POST INSPECTION MEMORANDUM

Operator Inspected:
Kelso-Beaver Pipeline Company
c/o Cascade Natural Gas Company
222 Fairview Ave N
Seattle, WA 98109

Facilities Inspected: This field inspection was to inspect the installation of finger drains (French drains) at the Flow Slide Area. This project is phase II of the overall project by PGE to stabilize the hillside (approximately 60-degrees slope) and protect the existing pipeline. During Phase I project, a geotextile fabric, drainage collection pipe, and 3" to 8" size rocks were installed in the area where the Flow Slide occurred. The purpose of Phase I project was to provide stability to the adjacent soil by placing approximately 9 foot thick rock mass at the head of the scarf and decreasing the depth of the rock mass to the toe of the hillside. Phase I was completed in early April of 2009. The Phase II project includes excavating 5 narrow and deep parallel trenches next to the Phase I project and fill the trenches with polystyrene aggregate. The separation between two adjacent trenches is approximately 10 feet. Two 4" diameter perforated corrugated plastic pipes surrounded by 4 inches of polystyrene aggregate are placed at the bottom

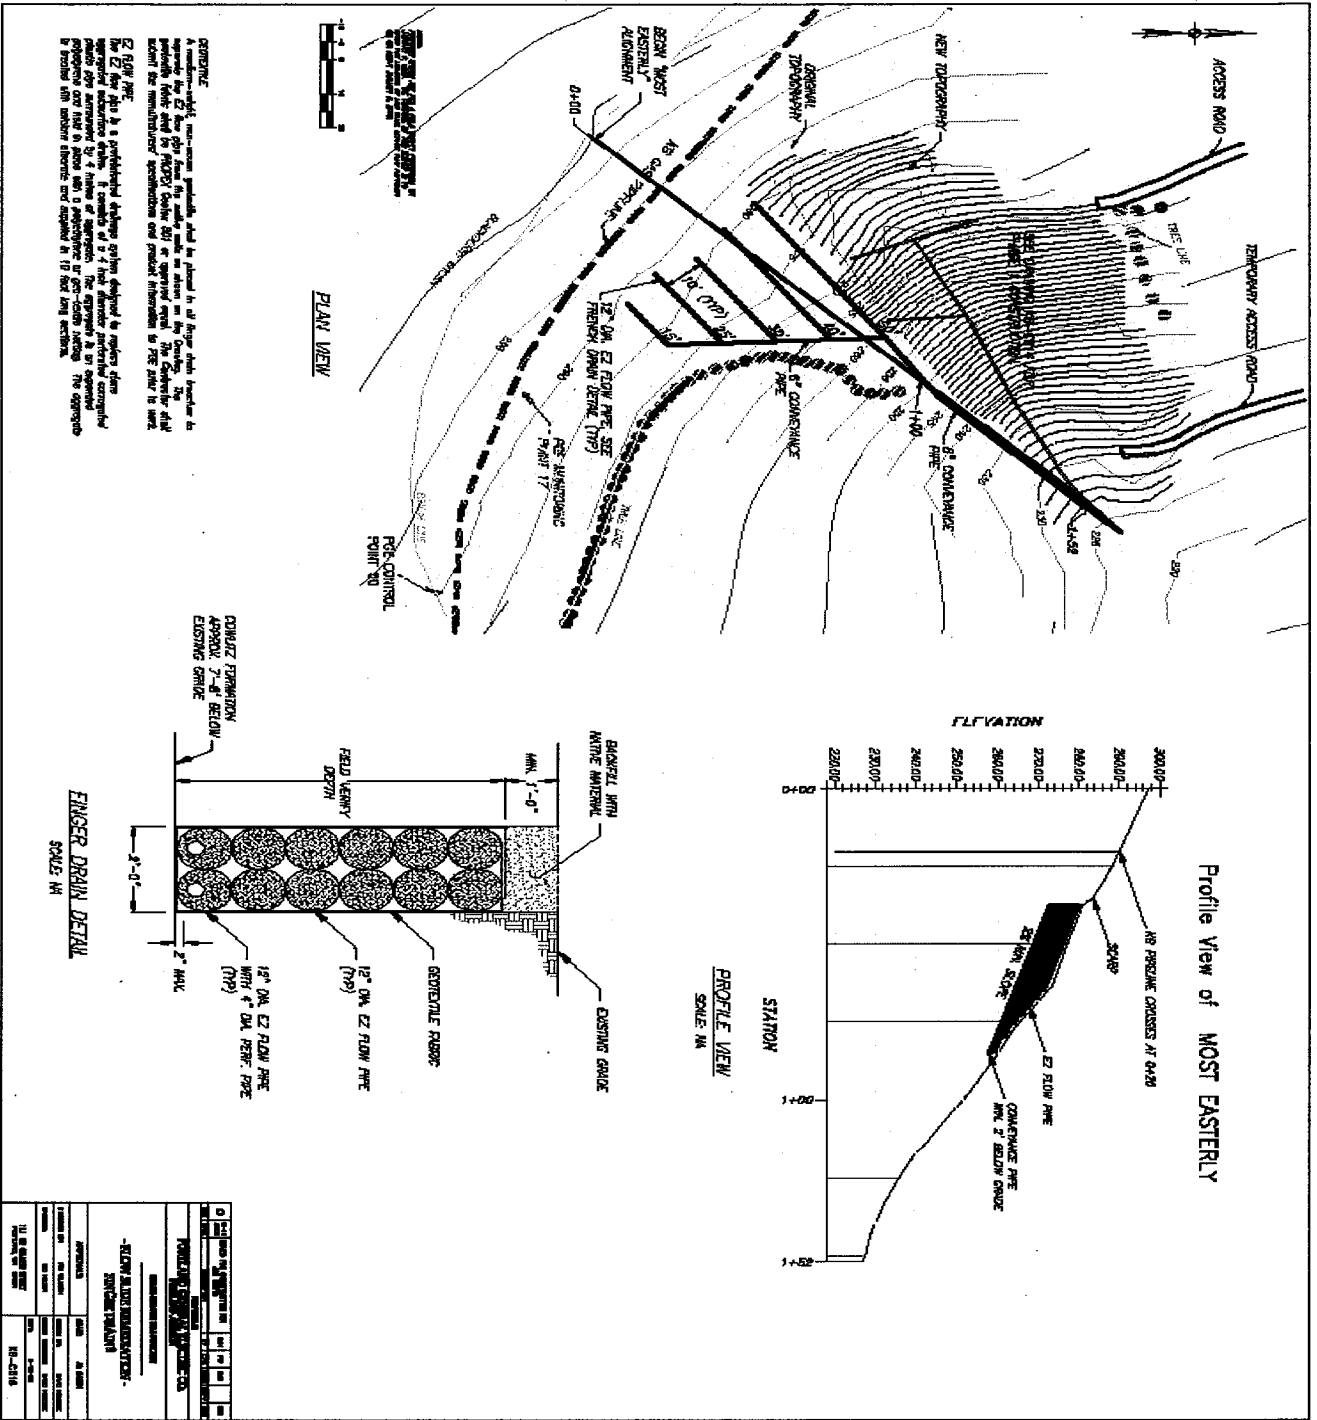
Probable Violations/Concerns: No probable violations identified. The Civil Engineer of PGE told us at the site that similar design has been implemented successfully elsewhere and this design was reviewed by their geotechnical consultant, Cornforth Consultants. When we asked about the scarf located up slope of the pipeline, the Civil Engineer explained to us that he only had to stabilize the ground down slope of the pipeline as the scarf located up slope of the pipeline was present during pipeline construction and it had not moved since the pipeline was constructed. We are not sure if the Phase I & II projects will significantly stabilize the slide area and protect the pipeline. PGE will continue to monitor the ground movement in the future by surveying elevation points along the ROW.

We believe the 20" pipe is under high stress at its current configuration. As indicated in our earlier inspection report, we recommended that the pipeline should be shut down, depressurized,

and the section around the Flow Slide Area be exposed to relieve pipe stress. PGE should consult with their geotechnical consultant to install French drains up-slope of the pipeline to minimize water up gradient from flowing into the area around the pipeline. If the section of the pipeline is to be buried again, we recommended the installation of strain gages and piezometers to monitor pipe stress and ground water level. Alternatively, the pipe section may be above ground with pile supports in lieu of strain gages.
